**Subject:** 548 / 52 Too Hot

**Number:** SRV0013

**Applicability:** StarPower 548  
StarPower 52 4F  
52 Platinum

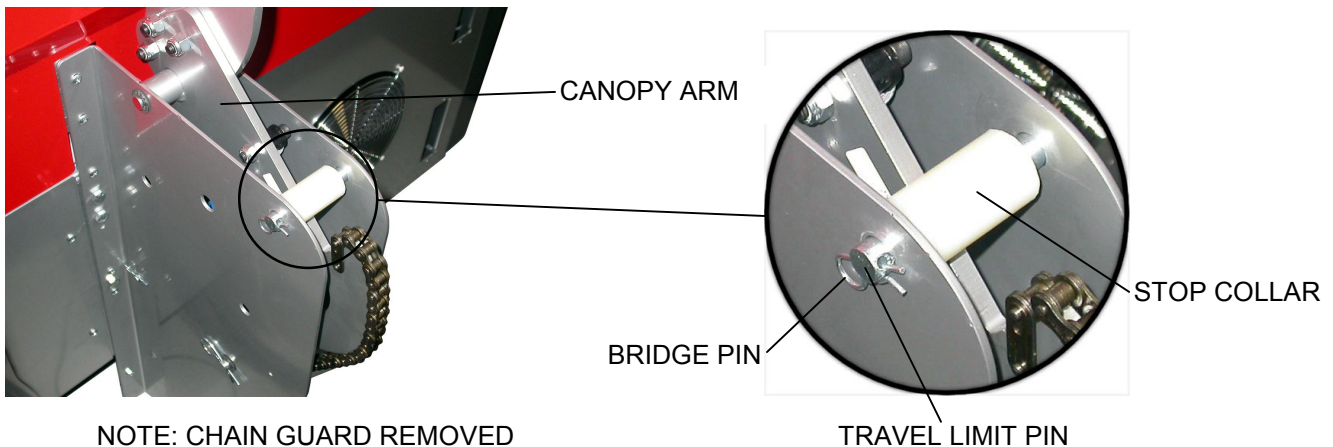
**Symptoms:** The canopy closes all the way, or very close, to the bench and the tanner is experiencing an extremely hot tanning session.

**Explanation:** The canopy, when fully closed, needs to be about 1" from the bench for proper ventilation during use. Due to manufacturing tolerances, some canopies may close too far to allow the proper ventilation.

**Solution:** A Stop Collar (ETS part number 26943-01, 2 needed per bed) is available to open the gap between the canopy and bench. When slipped over the Travel Limit Pins on the back of the unit (see pictures) the canopy arms hit the Stop Collars, causing the front edge to lift slightly.

To install, remove the chain guards if necessary. Pull out the bridge pin and remove the Travel Limit Pin. Reinsert the Travel Limit Pin into the hinge brackets and Stop Collar. Secure the Travel Limit Pin with the bridge pin. Reinstall the chain guards if necessary.
